EXHIBIT 7

July 26, 2019

As you requested, this is a letter report on the vegetation management field inspections ("VM inspections") the Monitor team is conducting pursuant to the Court's April 3, 2019 Order ("April 3 Order"). This submission includes: (1) background information on the VM inspections; (2) an explanation of the VM inspections process; (3) the Monitor team's preliminary observations; (4) PG&E's feedback based on the Monitor team's preliminary findings; (5) the Monitor team's preliminary suggestions to PG&E, as shared with the Company on July 17, 2019; and (6) concluding thoughts.

I. OVERVIEW AND BACKGROUND

Figure 6: Excerpts of the first page of a sample potential exception report, reflecting the project location and description.

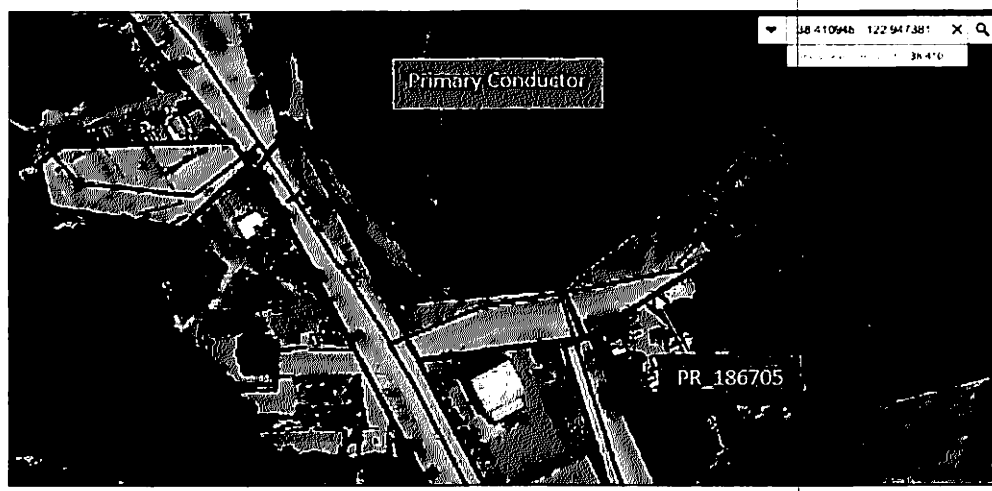
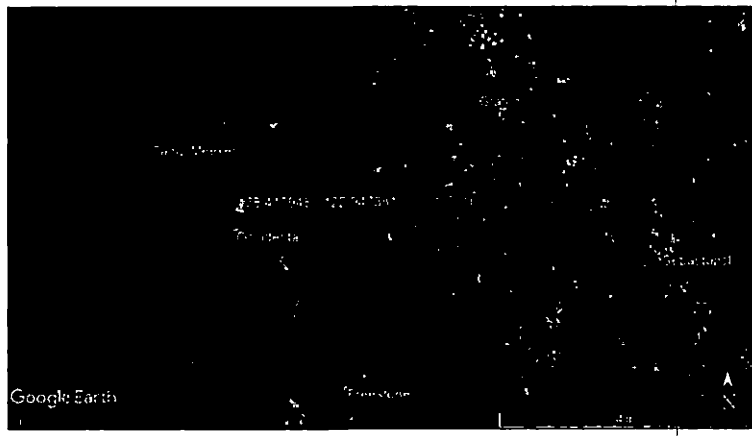
A potential hazard tree was found during a Monitor Inspection on June 18, 2019 of Project *PR_186705* on Circuit *Molino 1102*. In general terms, this circuit is located on the outskirts of the city of Sebastopol, CA, running approximately 10 miles to the west of the city. This circuit is located in/near a Tier 3 fire threat area pursuant to the ArcCollector database. The approximate position of the tree is denoted as the red circle in the second graphic below.

Figure 10: Tree found by Monitor team on July 11, 2019 that was in contact with a primary conductor.

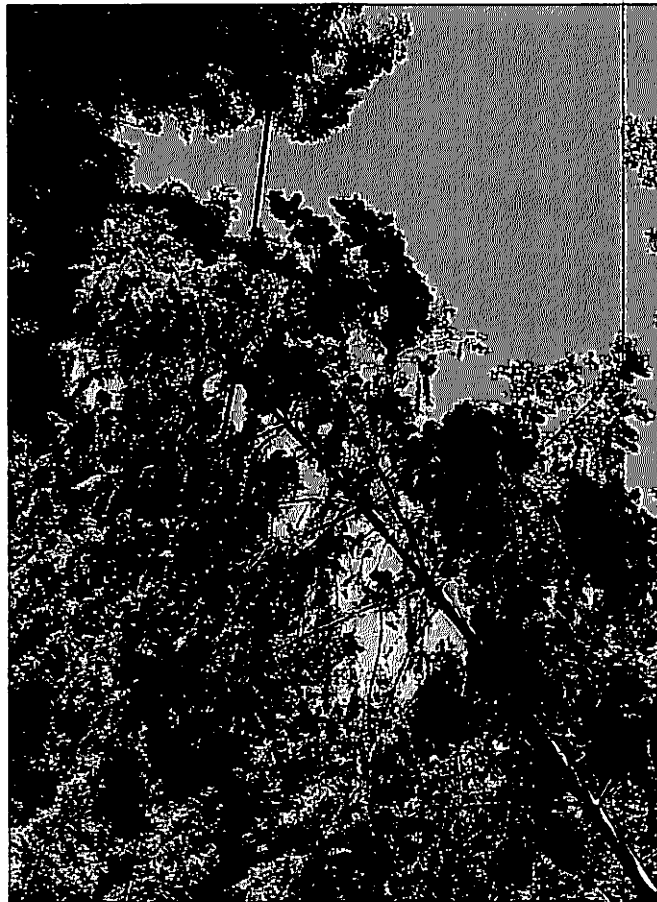
Second, on July 11, 2019, the Monitor team informed PG&E of a tree that was in contact with a primary conductor near the driveway of a private residence (see Figure 10 below). The Monitor team stayed in the area until a PG&E-dispatched pre-inspector arrived. The pre-inspector remained on the scene until a tree crew arrived to address the issue later that day.

Figure 13: Example of a potential overhang tree that was partially—but not fully—trimmed.

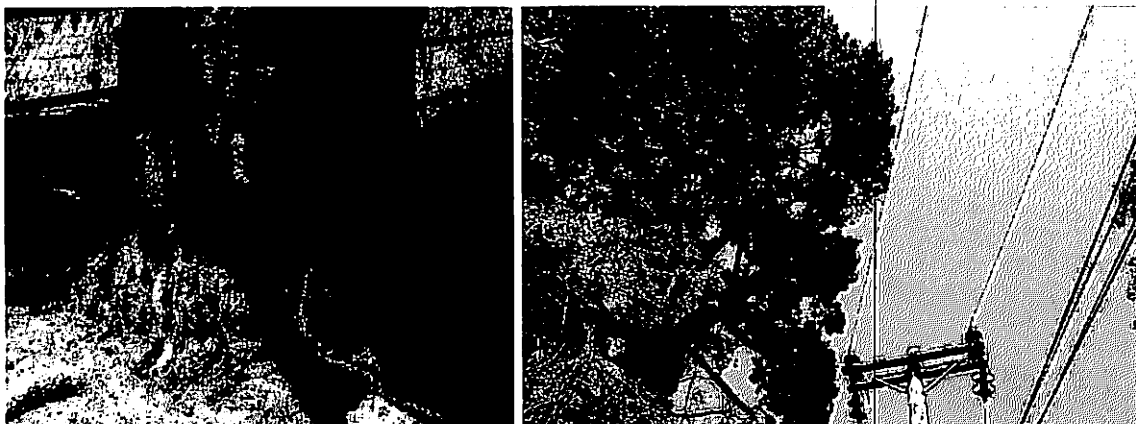
PG&E's EVM scope requires clearance of trees with vegetation currently overhanging a four-foot vertical plane over primary distribution lines, also known as "conductor-to-sky" clearance.

Figure 14: Example of a potential hazard tree that was marked with an X for removal (left photo) but did not appear in Arc Collector (right photo; trees prescribed for work are supposed to appear in Arc Collector as green triangles).

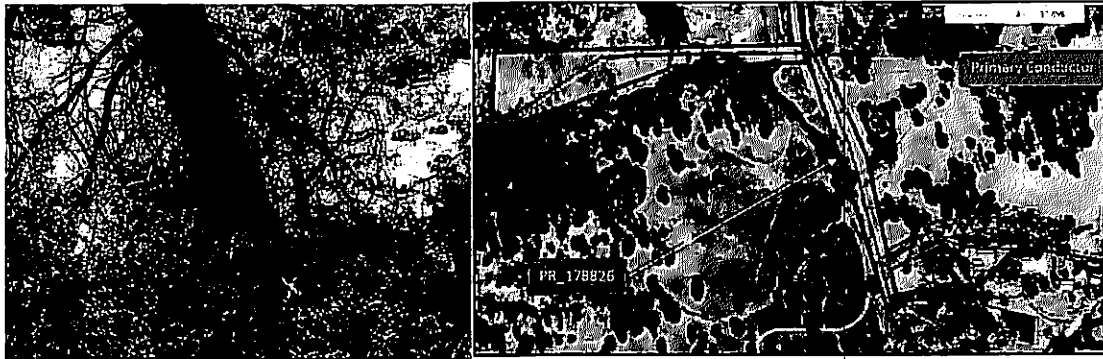
Some workers are simply not entering data into Arc Collector. Trees identified as requiring work under the EVM scope are supposed to be (1) physically marked with yellow paint or flagging, and (2) entered into Arc Collector. This is often not occurring—the Monitor team has identified numerous instances where trees that were physically marked for work were not included in Arc Collector, and vice versa. Either failure materially reduces the chance that proper remediation will occur.

Figure 19: The red triangles reflect customer refusals in Arc Collector. However, the comments (and the Monitor team's interactions with the customer) suggest that the customer did not refuse the work.

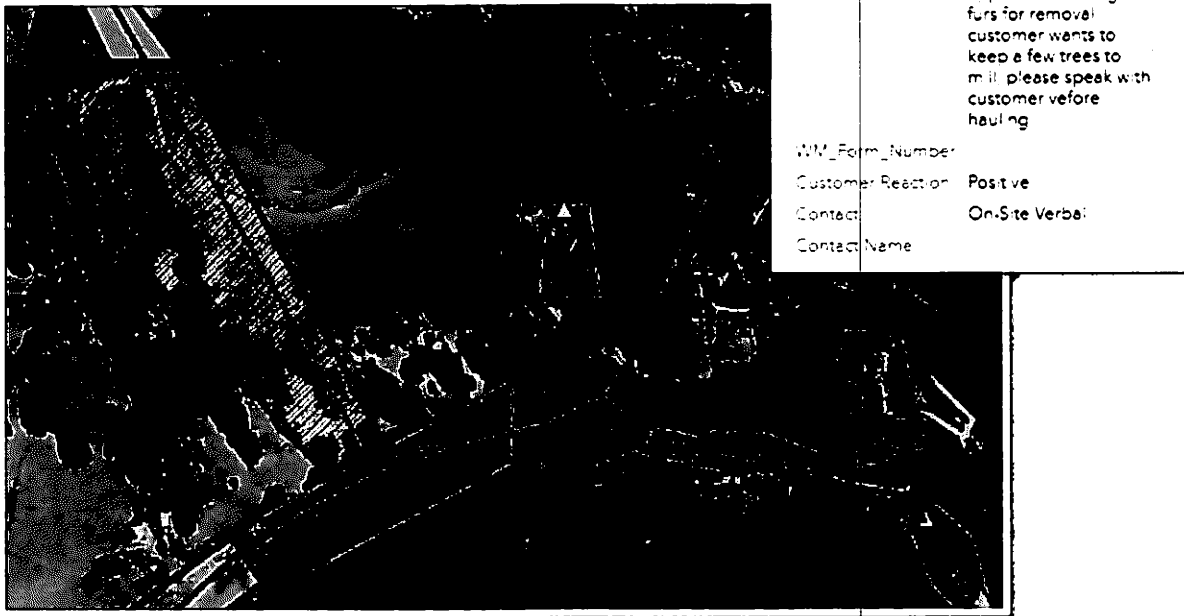
There is a lack of clarity regarding justifications for potential exceptions, such as customer refusal. For example, one particular project contained dozens of trees listed as customer refusals (the red triangles in Figure 19 below). However, the Monitor team interacted with the customer who stated that he did not refuse any work, and Arc Collector field notes also show that the customer approved recommended safety work.

Overhangs

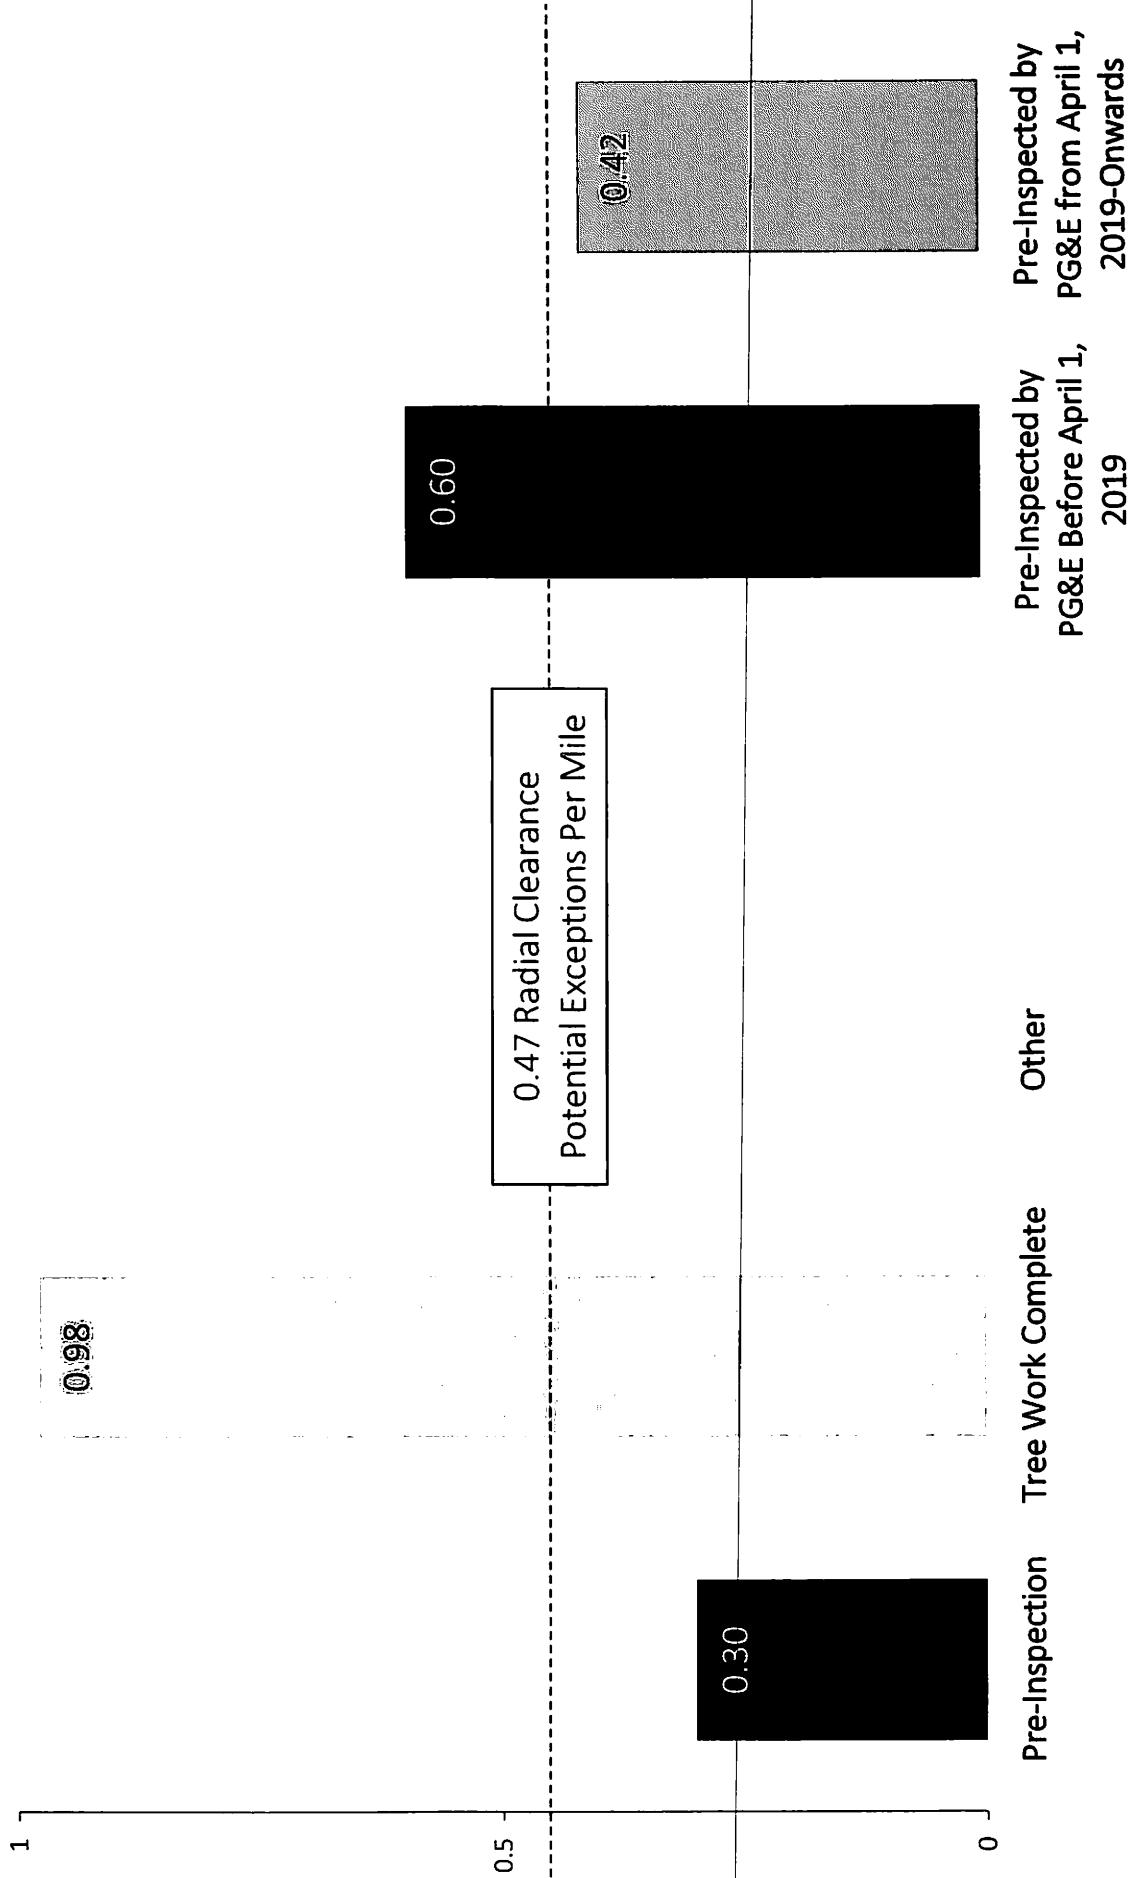
- The Monitor team noted multiple instances where overhangs were not completely cleared (*example photos below*).
- Relatedly, the Monitor team observed that some trees were pruned to clear overhanging vegetation up to a certain height, but the highest portion of the tree was not pruned.

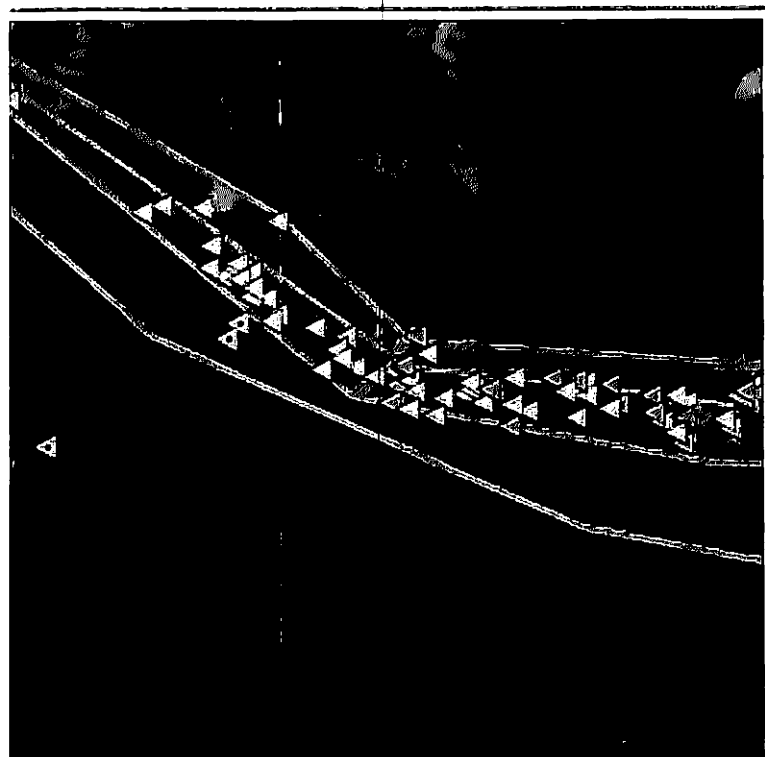
- Re-inspection after post-work verification is not recorded consistently. The Monitor team observed that inspectors came to an area and marked trees that needed to be remediated with yellow paint, but only added some of those trees into Arc Collector (*left photo, dark green triangles*). In other areas, pre-inspectors appeared to have re-inspected an area, with paint on trees needing remediation, but they made no additions on Arc Collector (*right photo*).

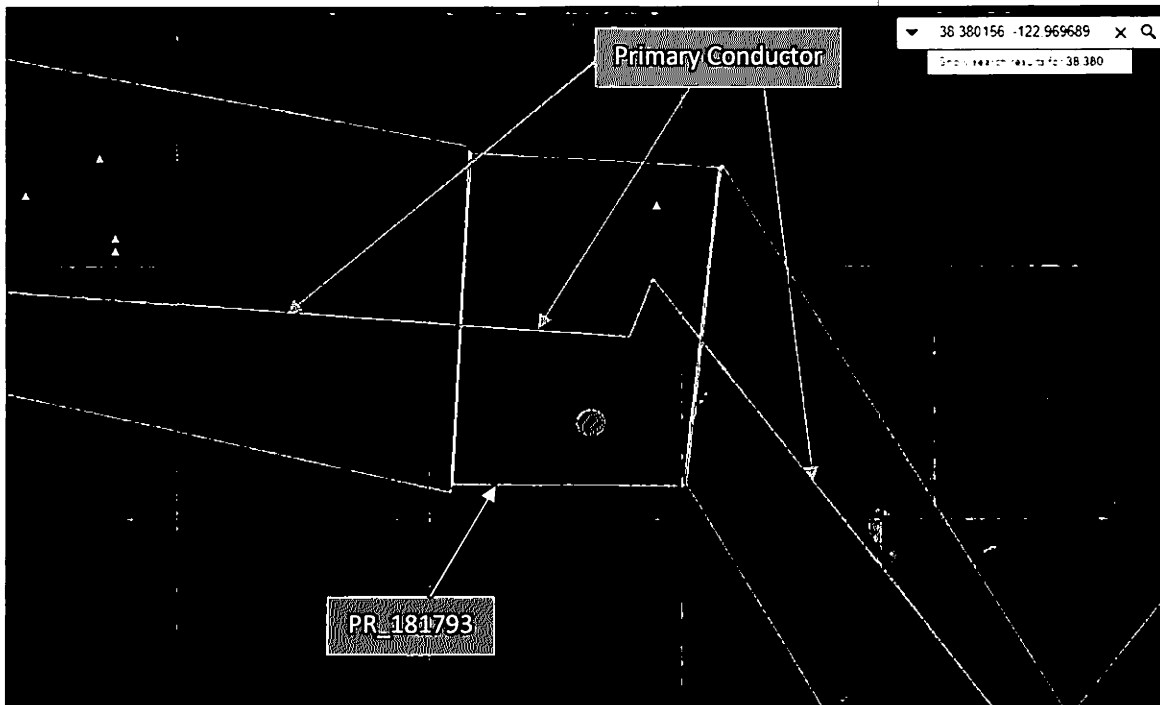
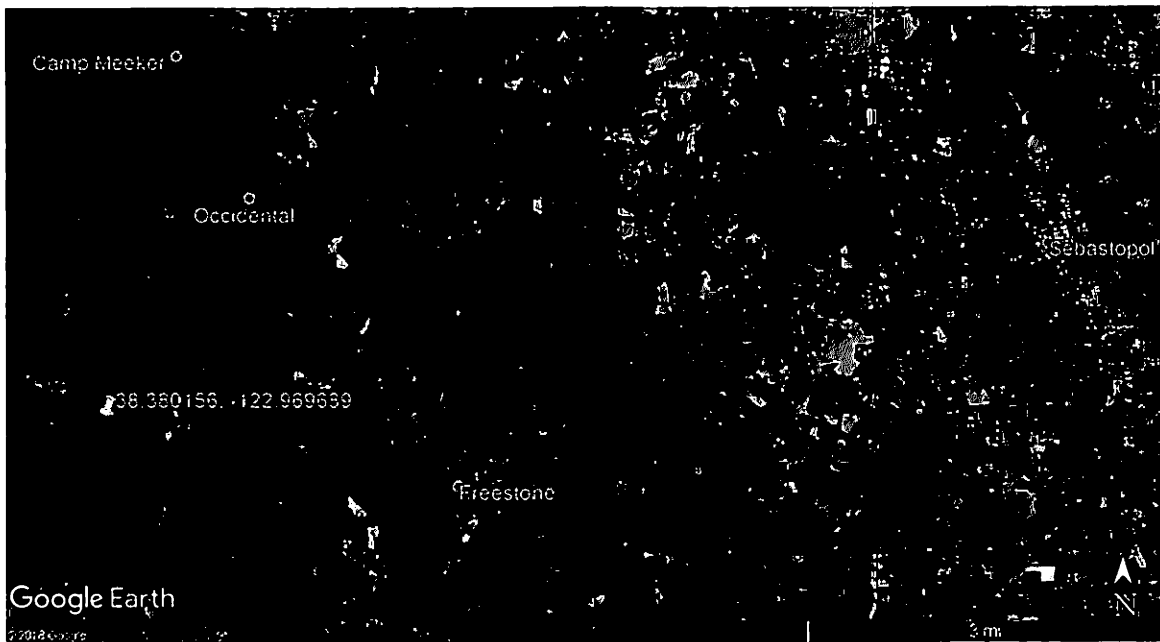
A potential hazard tree was found during a Monitor Inspection on July 10, 2019 of Project *PR_181793* on Circuit *Molino 1102*. In general terms, this circuit is located on the outskirts of the city of Sebastopol, CA, running approximately 10 miles to the west of the city. This circuit is located in/near a Tier 3 fire threat area pursuant to the ArcCollector database. The approximate position of the tree is denoted as the red circle in the second graphic below.

PG&E ArcCollector Project Status	Work Identified	
Monitor Team Observed Tree Work in Immediate Vicinity of Subject Tree	No	
Monitor Team Observed Recent Tree Work on Subject Tree	No	
Tree Paint or Other Markings Observed	No	
Species	Tan Oak	
GPS Coordinates	38.380156, -122.969689	
Approx. Distance from Primary Conductor	Trunk of tree 40 feet south	
Approx. Height	50 feet	
Veg Type	Potential Hazard Tree	
Monitor Arborist Comment	Observations of the tree include (a) trunk showing multiple cracks and signs of decay, (b) tree is leaning towards primary conductor, and (c) if tree fails, tree will contact primary conductor.

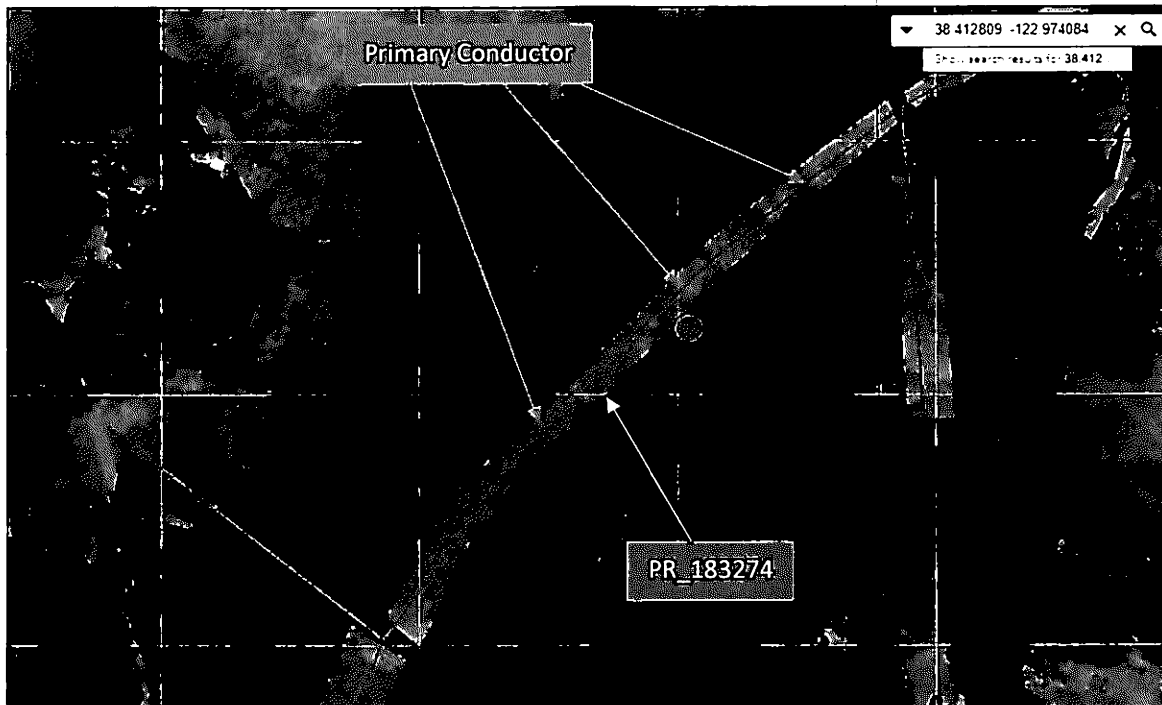
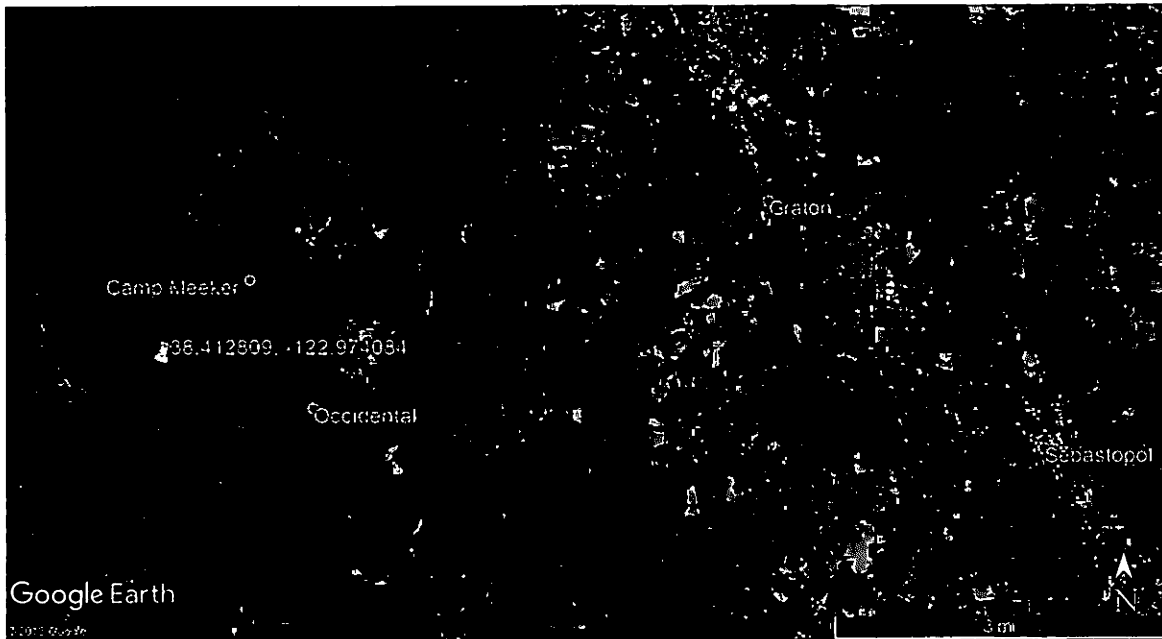
A potential hazard tree was found during a Monitor Inspection on July 8, 2019 of Project *PR_183274* on Circuit *Molino 1102*. In general terms, this circuit is located on the outskirts of the city of Sebastopol, CA, running approximately 10 miles to the west of the city. This circuit is located in/near a Tier 3 fire threat area pursuant to the ArcCollector database. The approximate position of the tree is denoted as the red circle in the second graphic below.

PG&E ArcCollector Project Status	No Work Required Under EVM
Monitor Team Observed Tree Work in Immediate Vicinity of Subject Tree	No
Monitor Team Observed Recent Tree Work on Subject Tree	No
Tree Paint or Other Markings Observed	No
Species	Coastal Redwood
GPS Coordinates	38.412809, -122.974084
Approx. Distance from Primary Conductor	Trunk of tree 18 feet south
Approx. Height	107 feet
Veg Type	Potential Hazard Tree
Monitor Arborist Comment	Observations of the tree include (a) soil erosion around root structure, (b) root loss, (c) compromised root anchorage, and (d) majority of branches and tree weight are on the side of the primary conductor.
